Access Compliance Report

Public Rights-of-Way

Intersection ID: 48001	Main Street: LARKMEAD_FOREST_DR	Cross Street: CLYMER_CT	Location: SE
ADA ID: 54BEE0DD8353	Ramp Type: Perp	Initial Pass/Fail: Fail	Overall Compliance: No
Codes/Mitigation Info/Possible Solution			Severity Score: 10
			Field Measurements/Component Compliance

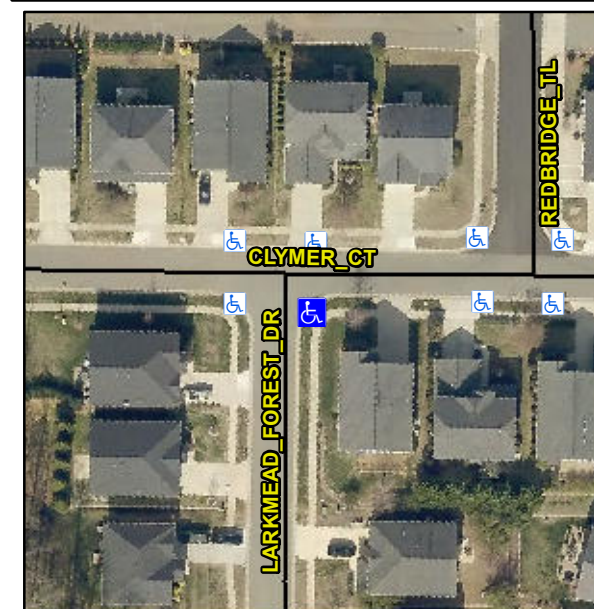
Not Found, R304.5.1, R304.5.3

Compliance	Description	Data	Compliance	Description	Data
N/A	Ramp Length (in)	72.0	Yes	Ramp Slope (%)	6.8
No	Ramp Width (in)	42.5	No	Ramp XSlope (%)	5.0
N/A	Flare Type LT	N/A	N/A	Flare Type RT	N/A
N/A	Flare Slope LT (%)	N/A	N/A	Flare Slope RT (%)	N/A
N/A	Flare Traversable LT?	N/A	N/A	Flare Traversable RT?	N/A
N/A	Landing Length (in)	N/A	N/A	DWS Provided?	N/A
N/A	Landing Width (in)	N/A	N/A	DWS Contrast?	N/A
N/A	Landing Slope (%)	N/A	N/A	DWS Length (in)	N/A
N/A	Landing X Slope (%)	N/A	N/A	DWS Full Width?	N/A
N/A	Landing Curb? (Y/N)	N/A	N/A	DWS Offset (in)	N/A
N/A	Shared Landing?	N/A			
N/A	Gutter Ponding?	N/A	N/A	Gutter Slope (%)	N/A
N/A	Gutter Lip Ht (in)	N/A	N/A	Gutter X Slope (%)	N/A
N/A	Painted X Walk1?	No	N/A	Painted X Walk2?	N/A
	X Walk 1 Direction	To W		X Walk 2 Direction	N/A
N/A	X Walk 1 Width (in)	N/A	N/A	X Walk 2 Width (in)	N/A
	X Walk 1 Slope (%)	0.3		X Walk 2 Slope (%)	N/A
	X Walk 1 X Slope (%)	4.1		X Walk 2 X Slope (%)	N/A

Remove & Replace Entire Ramp.
